United States Nuclear Regulatory Commission  
Attachment IV to Serial: RNP-RA/97-0176  
(454 Pages)

H. B. ROBINSON STEAM ELECTRIC PLANT, UNIT NO. 2  
TECHNICAL SPECIFICATIONS CHANGE REQUEST TO CONVERT TO THE  
IMPROVED STANDARD TECHNICAL SPECIFICATIONS

SUPPLEMENT 7

SUPPLEMENT 7  
CONVERSION PACKAGE SECTION 1.0  
PAGE INSERTION INSTRUCTIONS

APPLICABILITY

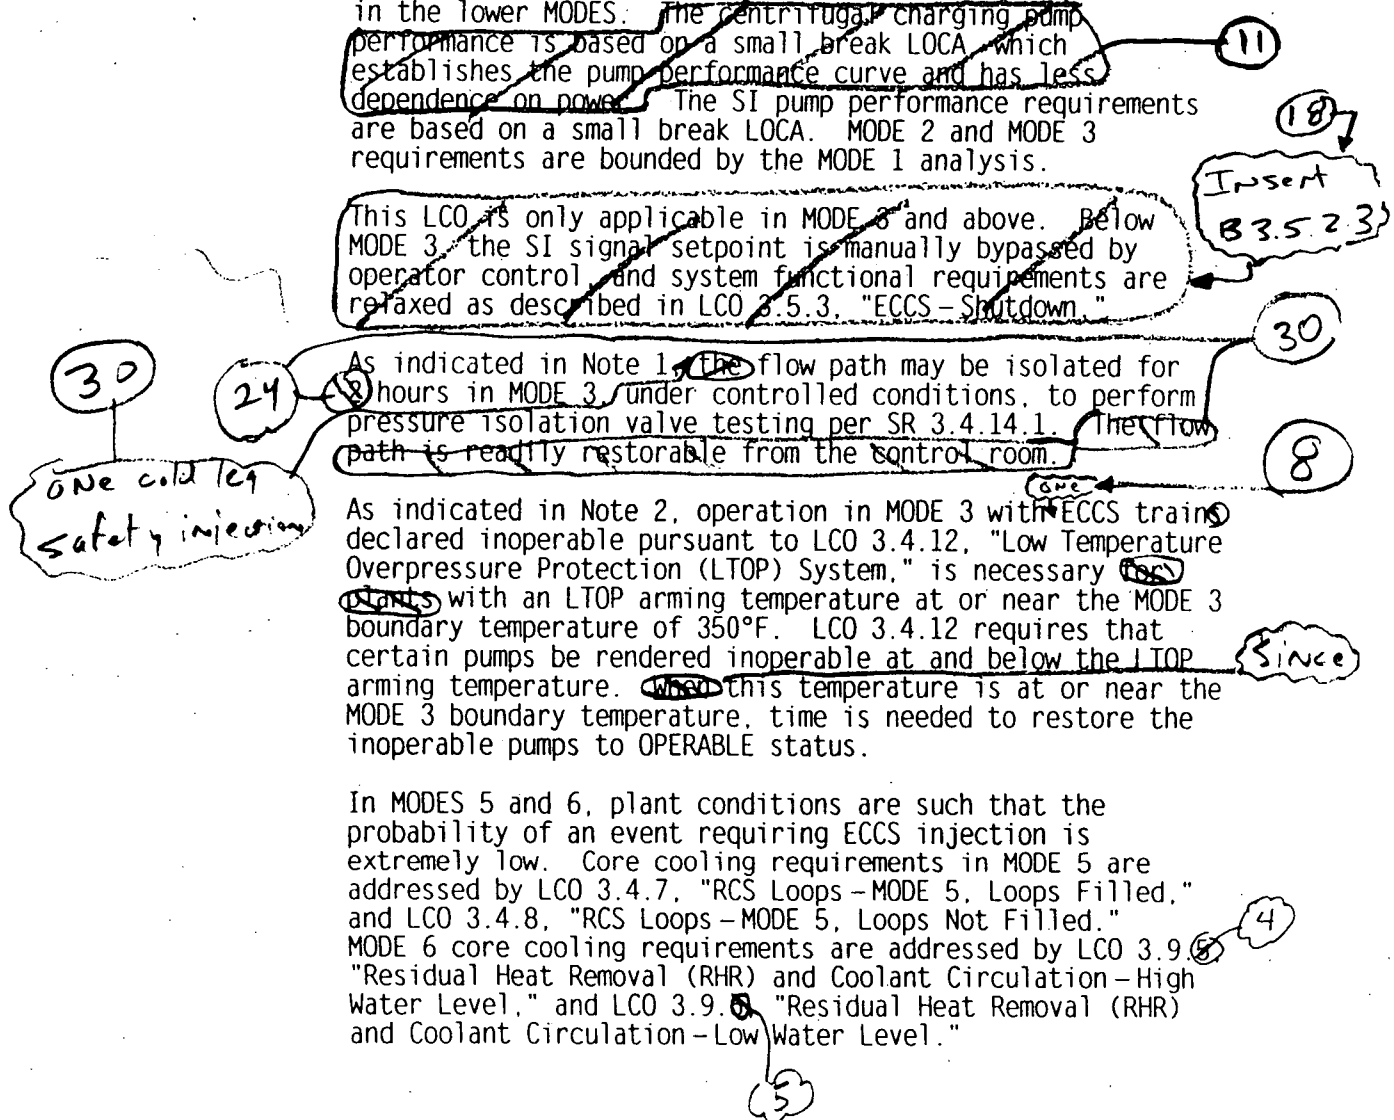
~~This LCO is only applicable in MODE 3 and above. Below MODE 3, the SI signal setpoint is manually bypassed by operator control, and system functional requirements are relaxed as described in LCO 3.5.3, "ECCS - Shutdown."~~

In MODES 1, 2, and 3, the ECCS OPERABILITY requirements for the limiting Design Basis Accident, a large break LOCA, are based on full power operation. Although reduced power would not require the same level of performance, the accident analysis does not provide for reduced cooling requirements in the lower MODES. ~~The centrifugal charging pump performance is based on a small break LOCA which establishes the pump performance curve and has less dependence on power.~~ The SI pump performance requirements are based on a small break LOCA. MODE 2 and MODE 3 requirements are bounded by the MODE 1 analysis.

Sec  
3.6.2

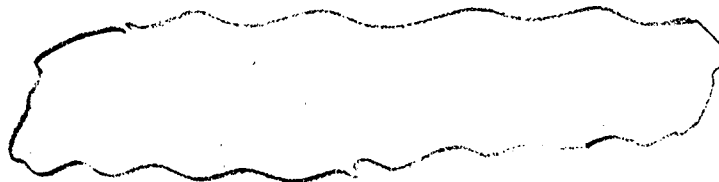
Add SR3.6.1.1 — (A5)
